Subject: Special Permit Time Extension (P85-405)

PROPOSAL: The applicant is requesting a one year time extension for a Special Permit for an 18 percent density bonus approved by the Planning Commission on November 14, 1985.

LOCATION: Northwest corner of Fruitridge Road and 65th Street Expressway.

# FRUITRIDGE VILLAGE

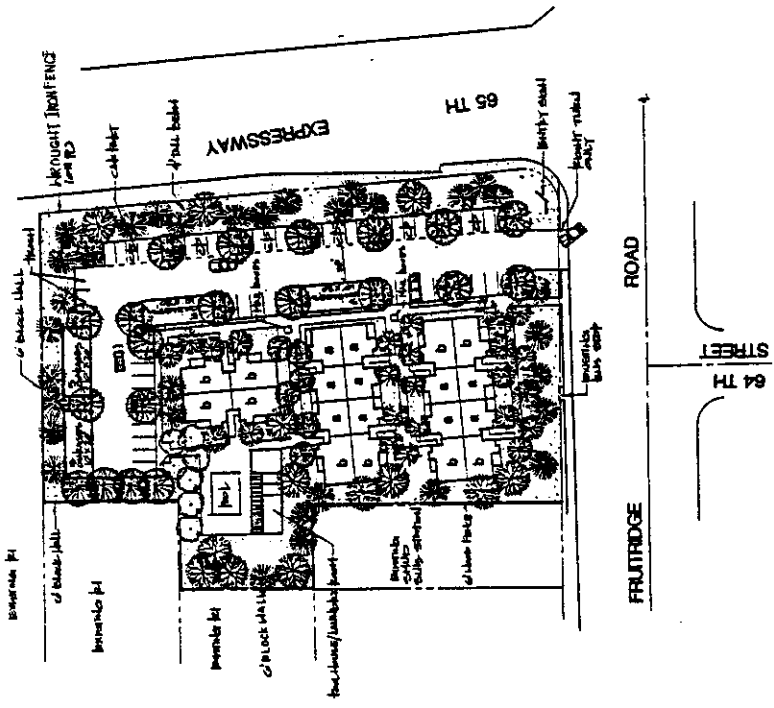
The submitted site plan indicates 48 residential units. The applicant is currently revising the site plan to indicate 40 units and a greater setback between building clusters.

Seventy-two parking spaces are currently shown on the site plan for a parking ratio of 1.5 spaces per unit. On the revised site plan the 1.5:1 parking stall ratio should be retained.

One trash enclosure is indicated at the northern portion of the site. A second trash enclosure should also be indicated somewhere on the southern portion of the site. Trash enclosures shall follow the guidelines found in the attached Multiple Family Residential Design Criteria (Exhibit F).

A solid block wall is indicated along the north property line and a portion of the west property line. This block wall should extend south to the parcel where the

SMUD substation is located (Exhibit C). If a solid block wall is not required along the SMUD parcel as a noise mitigation measure, a wooden fence or a chainlink fence with wood slats should be provided as a visual buffer between the substation and apartment units.

A four foot high undulating berm is indicated in the setback area along 65th Street and Fruitridge Road. A landscape plan for this area indicating a variety of trees and screening shrubs for parking areas and plans for the remainder of the site should also be submitted for staff review and approval. Staff also recommends that, in order to prevent public access to the site from the 65th Street Expressway, that a decorative wrought iron fence be provided along the east property line if a solid masonry wall is not required as a mitigation measure.

1. The applicant shall revise the submitted site plan for the review and approval of the Planning Director prior to issuance of building permits. The revised site plan shall indicate the following:

- a. A maximum of 40 apartment units;
  - b. A parking ratio of 1.5 spaces per unit;
  - c. A minimum of two trash enclosures;
  - d. A solid block wall along the north property line and a portion of the west property line as indicated on Exhibit C. The design and materials of the wall are subject to Planning Director review and approval;

- e. A wood fence or chainlink fence with wood slats along the west property line adjacent to the SMUD substation (this condition is void if a solid wall is required as a noise mitigation measure);

- f. A decorative wrought iron fence along the east property line adjacent to 65th Street (this condition is void if a solid wall is required as a noise mitigation measure);

- g. The location of carports and any enclosed garages.
2. A revised landscape, shading and irrigation plan shall be submitted for staff review and approval prior to issuance of building permits. The revised plans shall indicate a minimum four foot high undulating berm
